UN Regulation No. 14 (Safety-belt anchorages)

Proposal for Corrigendum 2 to Revision 5 to UN Regulation No. 14 (Safety-belt anchorages)

Note by the secretariat *

Figure 1a, shall be deleted

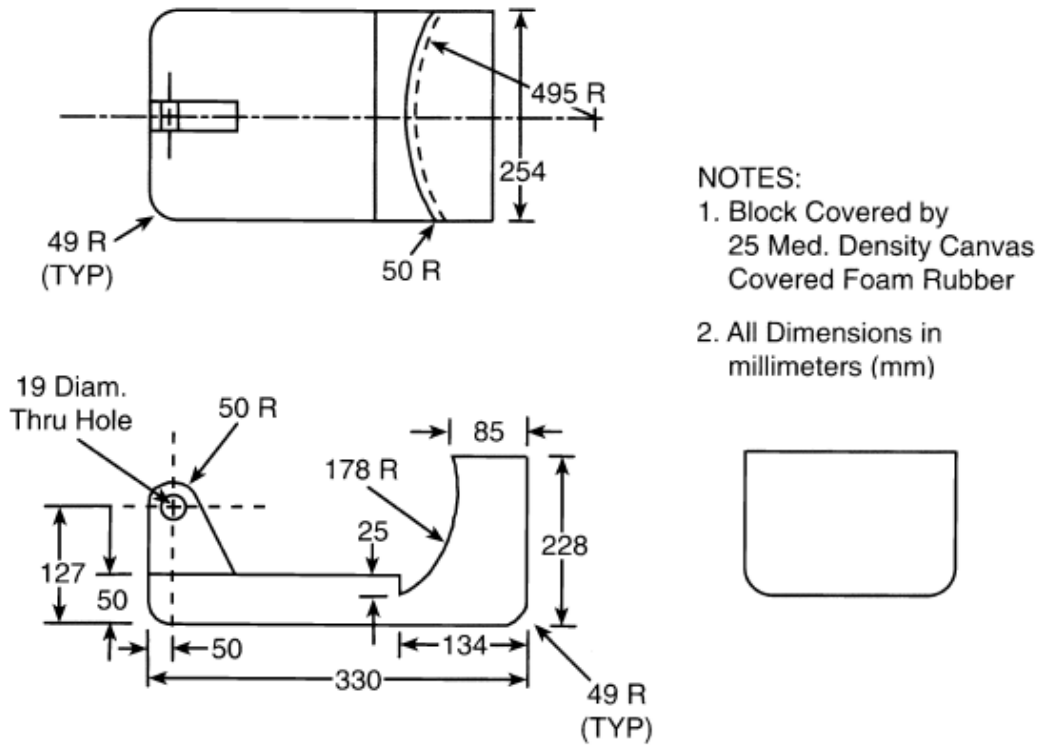
The text reproduced below was prepared by the secretariat to correct and improve the quality of the image of Figure 1a of Annex 5 to the UN Regulation.

Annex 5,

Insert new figure 1a, to read:
